# National Committee on Uniform Traffic Control Devices

Item No.: 20B-TTC-03

## NCUTCD Proposal for Changes to the Manual on Uniform Traffic Control Devices

Shoulder Work

Figure 6H-3. Work on the Shoulders (TA-3)

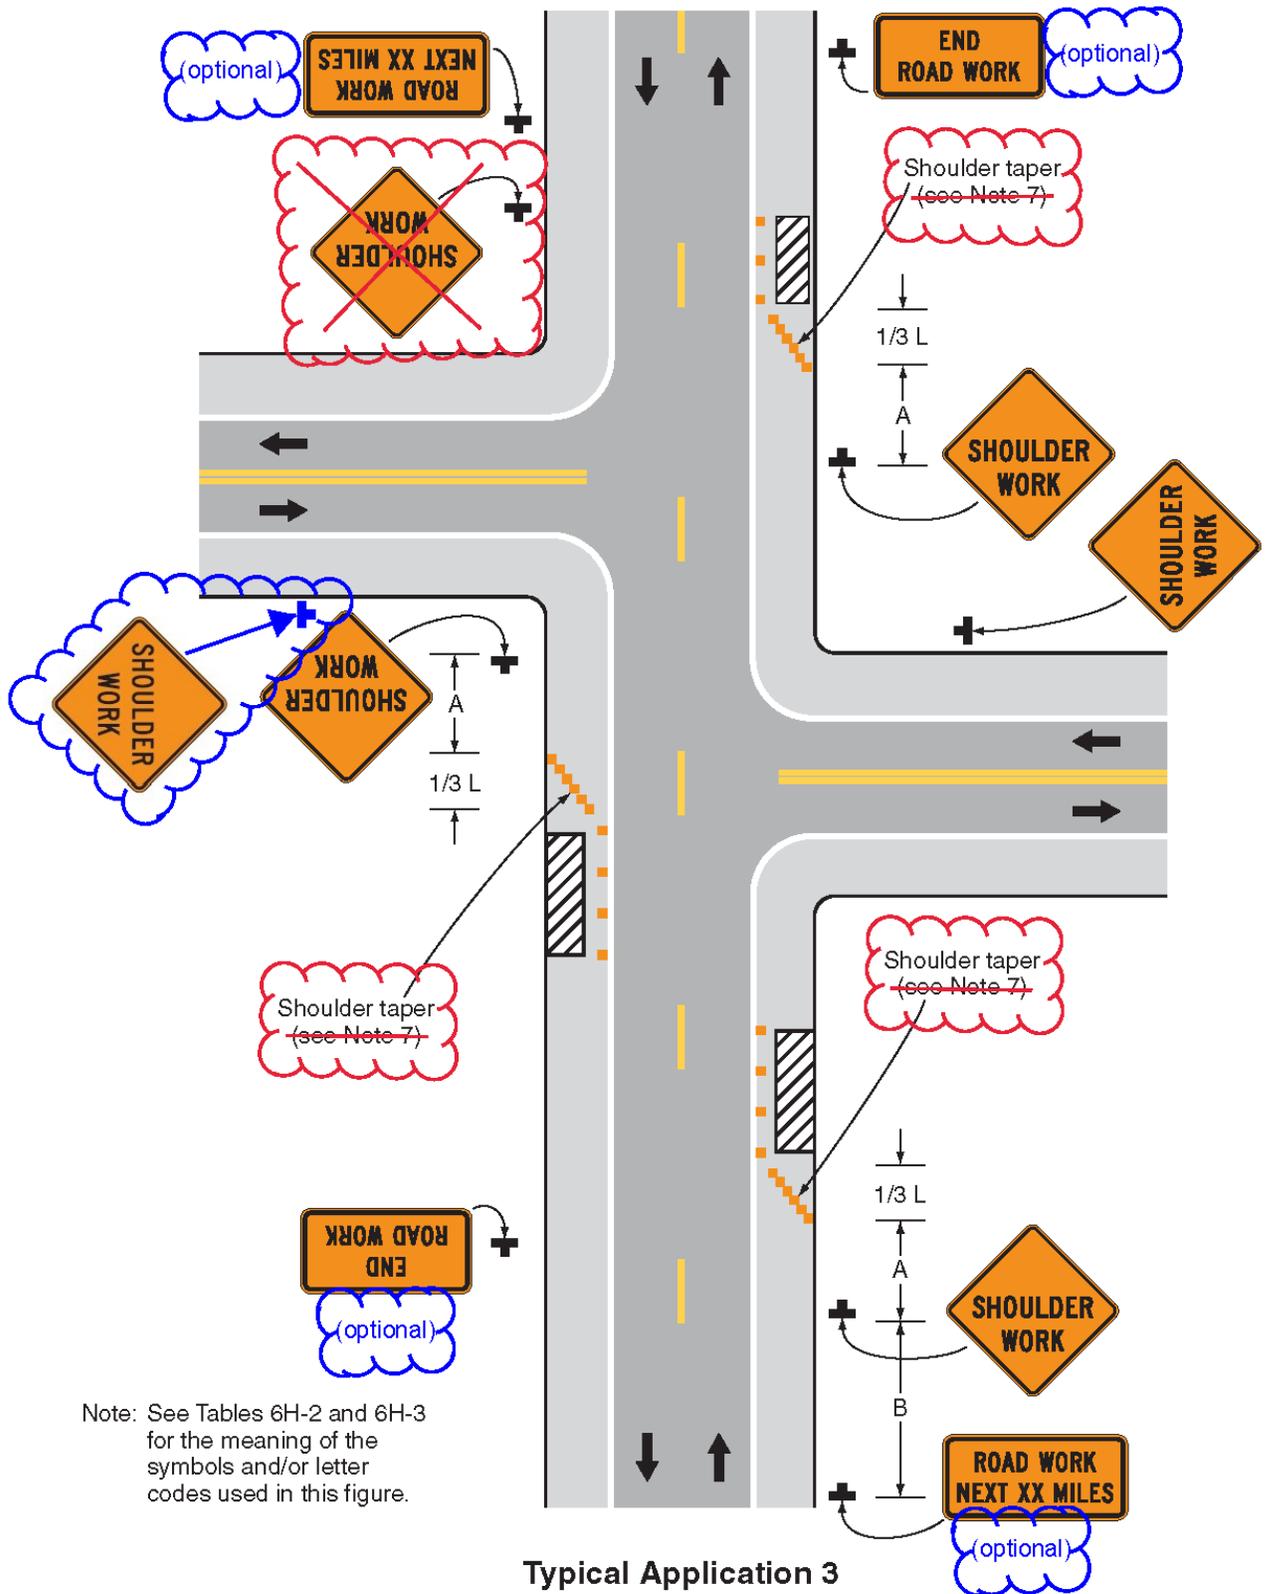
105 Note 1 recommends that “A SHOULDER WORK sign should be placed on the left side of the roadway  
106 for a divided or one-way street only if the left shoulder is affected.” Divided highways are covered by  
107 Typical Application 5 so it is proposed to delete “divided” from note 1. A slight modification is  
108 proposed to read “The SHOULDER WORK sign ...” and “... one-way street if only the left shoulder ...”  
109

110 Note 5 (numbering from 19B-TTC-02, originally note 4) provides an option for “short duration  
111 operations of 60 minutes or less”. However, short duration is defined in Section 6G.02, P02, D as “up to  
112 1 hour.” The intent of Typical Application 3 is to address short-term stationary to long-term stationary  
113 work since Typical Application 4 addresses short-duration or mobile operations. Since notes 4 through 6  
114 apply to short duration operations, it is proposed to delete notes 4 through 6 and add a new note to “See  
115 Figure 6H-4 for short duration and mobile operations.”  
116

117 Note 8 (numbering from 19B-TTC-02, originally note 7) is already covered in Section 6G.07, P02 and  
118 proposed P11a in Section 6C.08. To avoid redundancy, the note is proposed to be deleted.  
119

120 In Figure 6H-3, the SHOULDER WORK sign shown in the top left corner is redundant and should be  
121 removed. If the “A” dimension to the remaining SHOULDER WORK sign shown on the left or shoulder  
122 taper extend past the intersection, then the practitioner should place the sign, or sign and taper should be  
123 on the other side of the intersection. A SHOULDER WORK sign is added to the left side of the figure to  
124 warn a driver turning left of the shoulder work near the top right of the drawing. The “(see note 7)”  
125 under Shoulder taper note is proposed to be removed since the note is proposed to be deleted. Added the  
126 text “(optional)” next to the END ROAD WORK and ROAD WORK NEXT XX MILES signs to be  
127 consistent with other typical applications.  
128

- 398 1. *A The SHOULDER WORK sign should be placed on the left side of ~~the roadway for a divided or a~~ one-*  
399 *way street ~~only~~ if only the left shoulder is affected.*

- 417 5. See Figure 6H-4 for short duration and mobile operations.

Figure 6H-4 Short Duration or Mobile Operation on a Shoulder (TA-4)

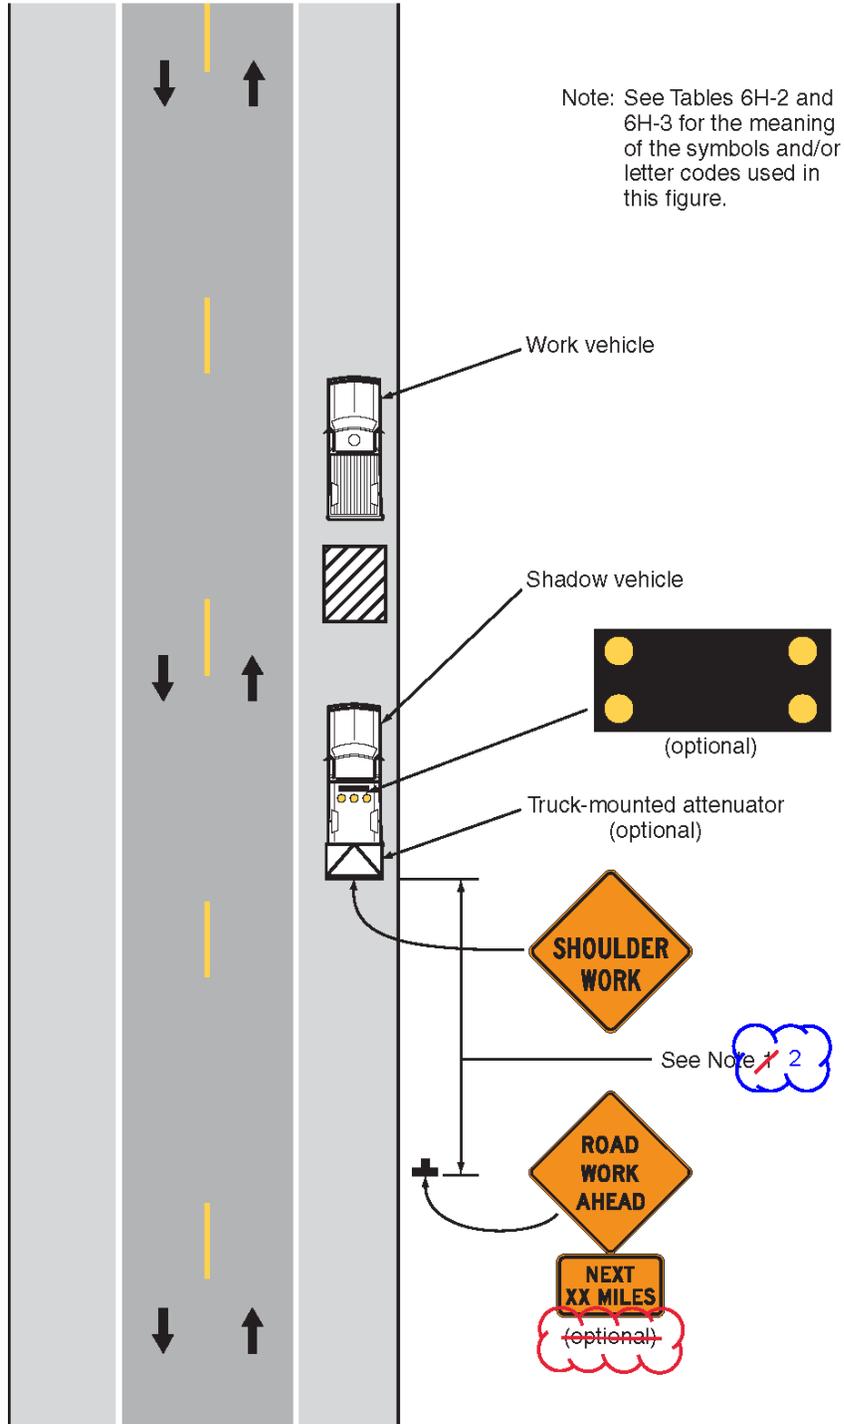
130 It is proposed that a new standard be added before note 1, similar to Typical Applications 17 and 35  
131 reading “Shadow and work vehicles shall display high-intensity rotating, flashing, oscillating, or strobe  
132 lights.”  
133

134 Note 5 (originally note 3 and then note 4 in 19B-TTC-02) provides an option of replacing ROAD WORK  
135 AHEAD sign with a ROAD WORK NEXT XX MILES sign for work more than 2 miles. The sign  
136 should supplement, not replace, the advance warning sign. It is proposed to modify note 3 to indicate  
137 that the ROAD WORK NEXT XX MILES sign may be used before the ROAD WORK AHEAD sign.  
138 Further, it is proposed that a sentence be added that the Supplemental Distance plaque may be omitted  
139 from the ROAD WORK AHEAD sign assembly if the ROAD WORK NEXT XX MILES sign is used.  
140

141 The addition of a new note before note 1 makes the last half of note 4 unnecessary.  
142

143 A new note regarding use of a truck-mounted attenuator on the shadow vehicle or on the work vehicle is  
144 added for consistency with other typical applications.  
145

146 In the title for Figure 6H-4, “Short Duration” is hyphenated and the hyphen needs to be removed for  
147 consistency. The specific reference to a note number is corrected to reflect the new note numbering and  
148 “(optional)” is proposed to be removed from the Supplemental Distance plaque to reflect the guidance  
149 note regarding its use.  
150

- 1. Shadow and work vehicles shall display high-intensity rotating, flashing, oscillating, or strobe lights.**

- ~~1.2.~~ *In those situations where multiple work locations within a limited distance make it practical to place stationary signs, the distance between the advance warning sign and the work should not exceed 5 miles.*
- ~~2.3.~~ *In those situations where When the distance between the advance warning signs and the work is 2 miles to 5 miles, a Supplemental Distance plaque should be used with the ROAD WORK AHEAD sign.*

- ~~3.4.~~ Additional positive protection devices may be used per Section 6F.84a. [approved by Council 01/10/2020]
- ~~4.5.~~ The ROAD WORK NEXT XX MILES sign may be used ~~instead of~~ before the ROAD WORK AHEAD sign if the work locations occur over a distance of more than 2 miles. If the ROAD WORK NEXT XX MILES sign is used, the Supplementary Distance plaque may be omitted from the ROAD WORK AHEAD sign assembly.
- ~~4.6.~~ Stationary warning signs may be omitted for short duration or mobile operations. ~~if the work vehicle displays high-intensity rotating, flashing, oscillating, or strobe lights.~~
- ~~5.7.~~ Vehicle hazard warning signals may be used to supplement high-intensity rotating, flashing, oscillating, or strobe lights.
8. A truck-mounted attenuator may be used on the shadow vehicle or on the work vehicle.

Figure 6H-5. Shoulder Closure on a Freeway or Expressway (TA-5)

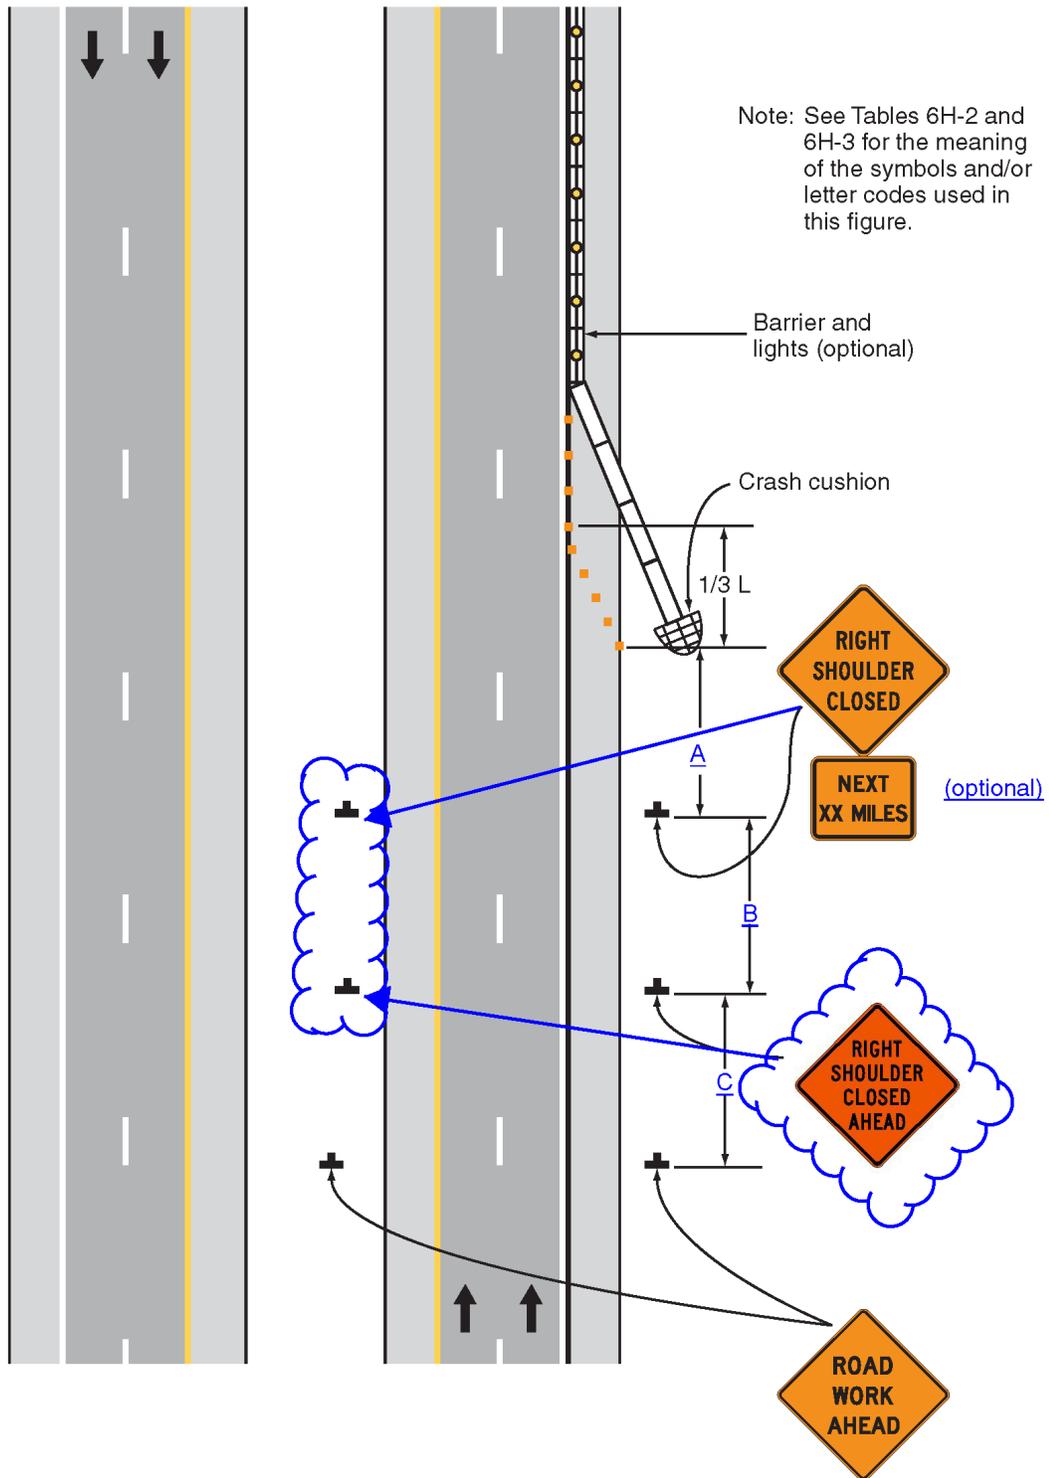
152 It is proposed that the typical application title on the notes page and figure be modified to include  
153 expressways.

154  
155 To correspond with Figure 6F-4 and Section 6F.37, note 1 should be revised to read RIGHT (LEFT)  
156 SHOULDER CLOSED.

157  
158 Note 2 recommends that if drivers cannot see a pull-off area, the length of the shoulder closure should be  
159 provided in feet or miles. To clarify the note, several revisions are suggested.

160  
161 The sign spacing dimensions in Figure 6H-5 are proposed to be revised to indicate ordinary A-B-C  
162 placement.

163  
164 In Figure 6H-5, the first shoulder closed assembly is a RIGHT SHOULDER CLOSED warning sign with  
165 a XX FT supplemental plaque. To conform with Section 6F.37, P02, the warning sign legend is proposed  
166 to be revised to RIGHT SHOULDER CLOSED AHEAD (W21-5b) with no plaque.

167  
168 In conjunction with the proposed modifications to Section 6G.07, P03, it is proposed in Figure 6H-5 that  
169 the SHOULDER CLOSED signs be shown on both left and right shoulders of a freeway or expressway.

- 453 1. RIGHT (LEFT) SHOULDER CLOSED signs should be used on limited-access highways where  
454 there is no opportunity for disabled vehicles to pull off the roadway.
- 455 2. If drivers cannot see a pull-off area beyond the closed shoulder, ~~information regarding a plaque~~  
456 indicating the length of the shoulder closure should be provided below the warning sign nearest  
457 the closure in feet or miles, as appropriate with the legend NEXT XX FT or NEXT XX MILES.
- 458 3. The use of a temporary traffic barrier should be based on engineering judgment.

Figure 6H-6. Shoulder Work with Minor Encroachment (TA-6)

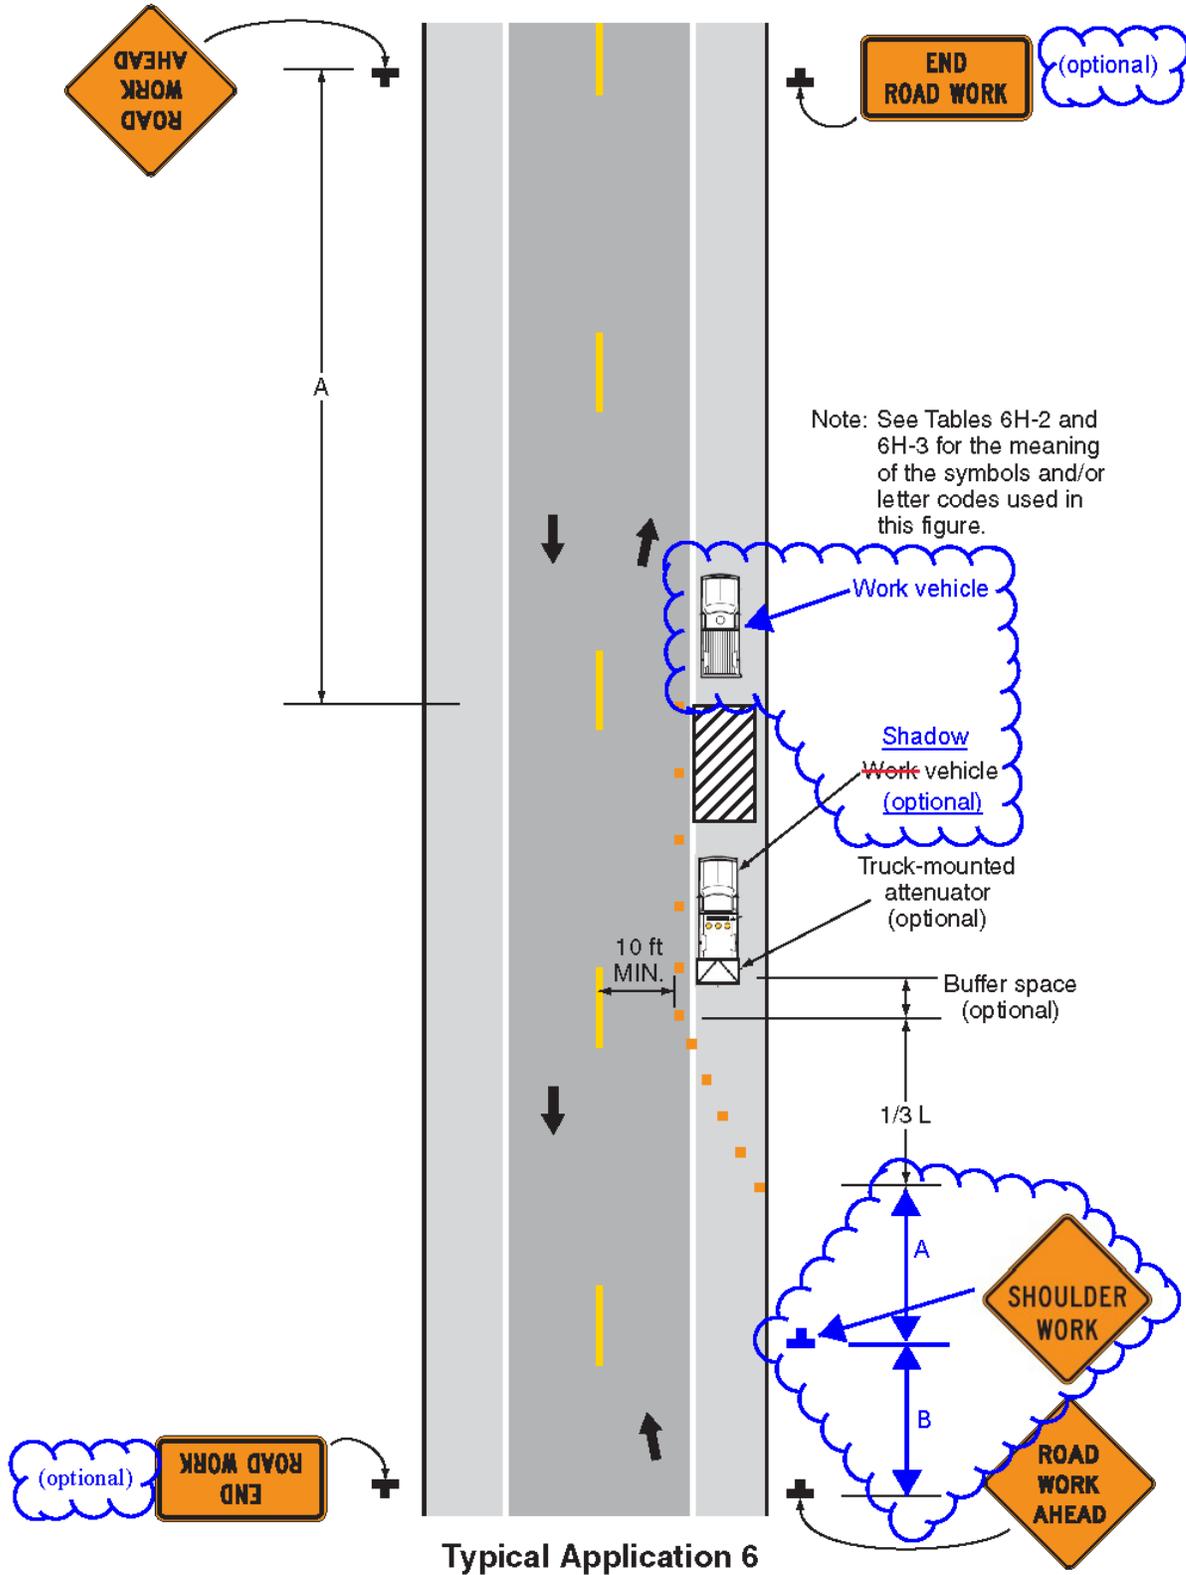
172 To stress their importance, it is proposed that notes 12 and 13 be moved to before note 1.

173  
174 Note 4 (originally note 2) is proposed to be revised to reference Typical Applications 10 or 12 if the  
175 roadway has higher volumes or higher speeds.

176  
177 Note 10 (originally note 8 and then note 9 in 19B-TTC-02) is proposed to be revised to correspond with  
178 proposed revisions to Figure 6H-6 and to indicate that a truck-mounted attenuator may also be used on  
179 the work vehicle for consistency with other typical applications.

180  
181 On Figure 6H-6, the work vehicle is proposed to be replaced with a work vehicle and a shadow vehicle to  
182 match the vehicles shown on Figure 6H-4. Since channeling devices are shown, the shadow vehicle is  
183 indicated as “(optional)” to correlate with note 10 (originally note 7, then note 8 in 19B-TTC-02). A  
184 SHOULDER WORK sign is proposed to be added near the bottom right corner of the figure. The text  
185 “(optional)” is added adjacent to the END ROAD WORK signs to be consistent with other typical  
186 applications.

- 1. Shadow and work vehicles shall display high-intensity rotating, flashing, oscillating, or strobe lights.** [Moved from note 12]
- 2. Vehicle hazard warning signals shall not be used instead of the vehicle's high-intensity rotating, flashing, oscillating, or strobe lights.** [Moved from note 13]

- ~~1.3.~~ All lanes should be a minimum of 10 feet in width as measured to the near face of the channelizing devices.
- ~~2.4.~~ The treatment shown should be used on a minor road having low speeds. For higher volume or higher-speed higher speed traffic conditions, a lane closure should be used as shown in Figure 6H-10 or Figure 6H-12.

- ~~7.10.~~ The shadow vehicle may be omitted if a taper and channelizing devices are used.
- ~~8.10.~~ A truck-mounted attenuator may be used on the shadow vehicle or on the work vehicle.
